Groundwater Transfer Review Summary Form

Transfer/PA # T- 14722

Ground Water Review Form:

Applicant Name: City of Monmouth

Map

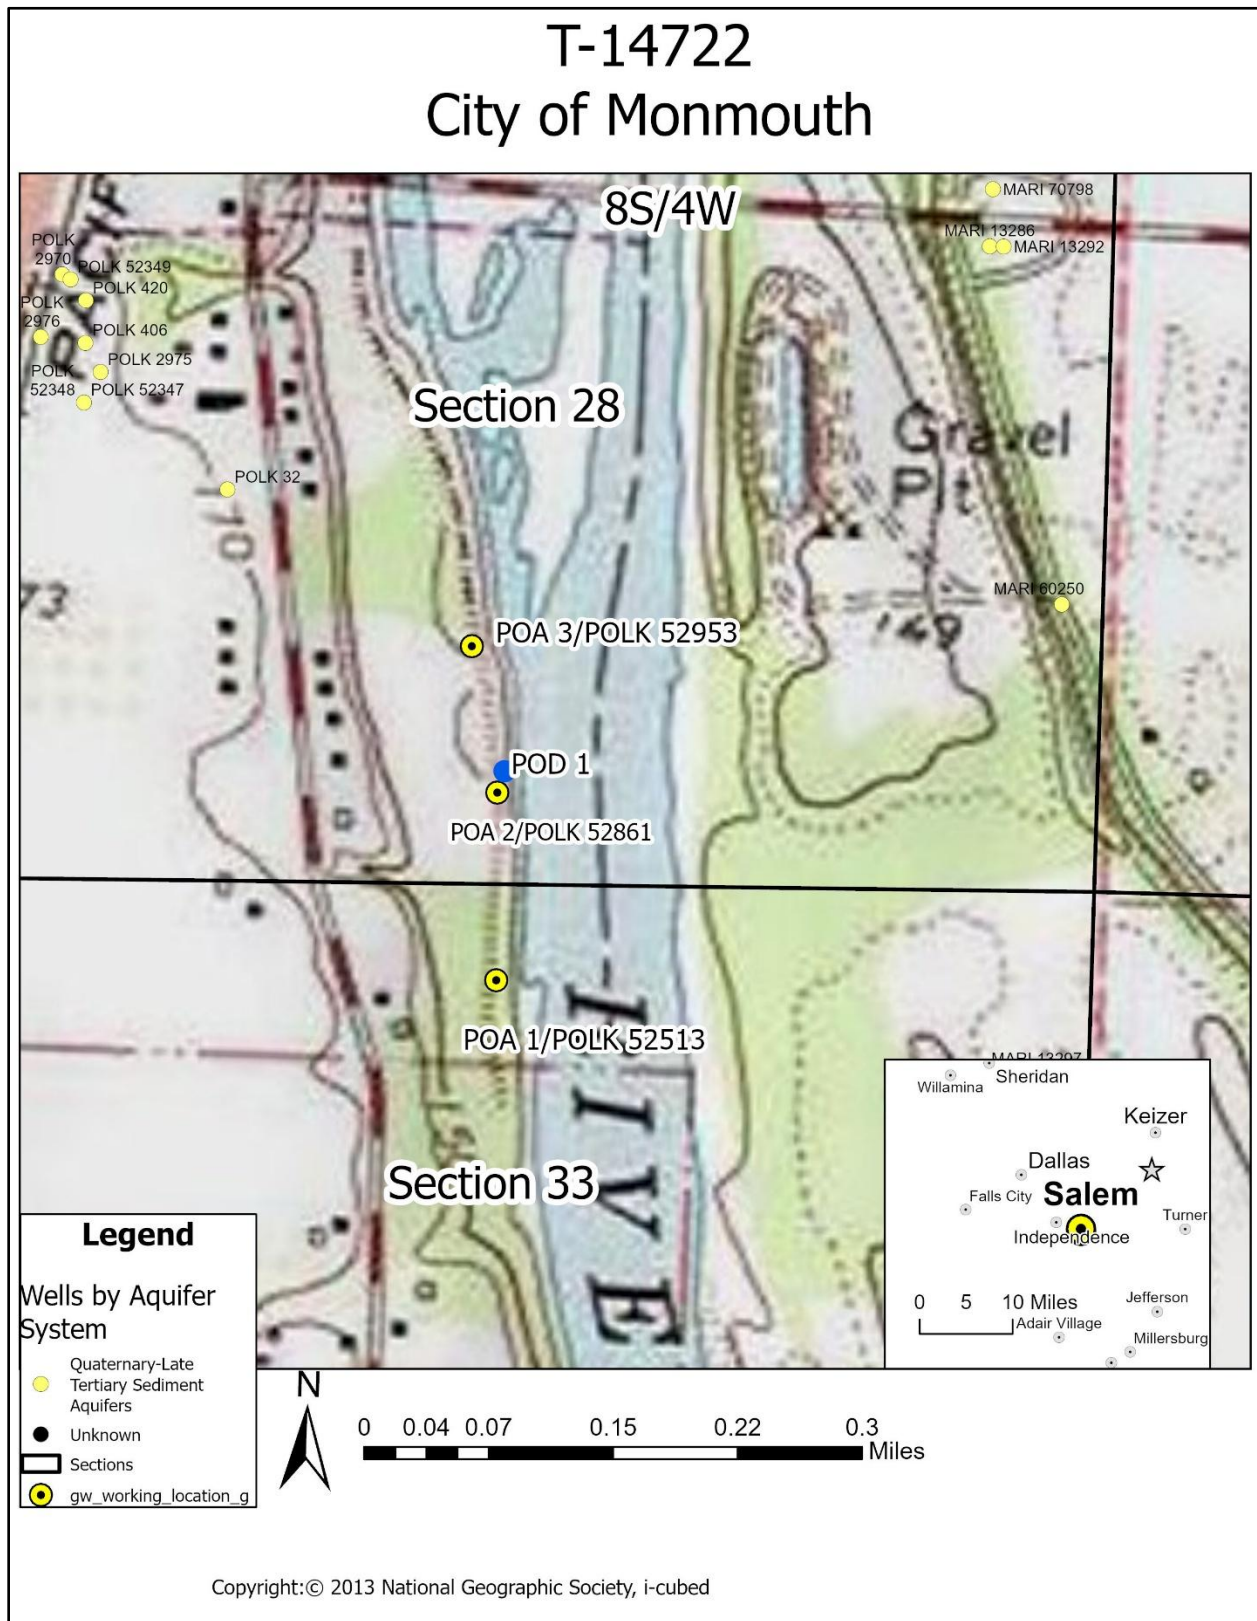
-
1. Basic description of the changes proposed in this transfer: Applicant proposes to transfer one surface water point of diversion, POD 1, authorized under permit S-54332 for municipal use at 4.46 cfs year-round to three existing wells: POLK 52513/POA 1, POLK 52861/POA 2, and POLK 52953/POA 3. All three POAs are also authorized under permit G-17868, but the stacked rights are not considered in this review as the additional authorization does not impact the analyses. The applicant also proposes adding a new surface water POD, however the additional surface water POD is not considered as part of this Groundwater Review.
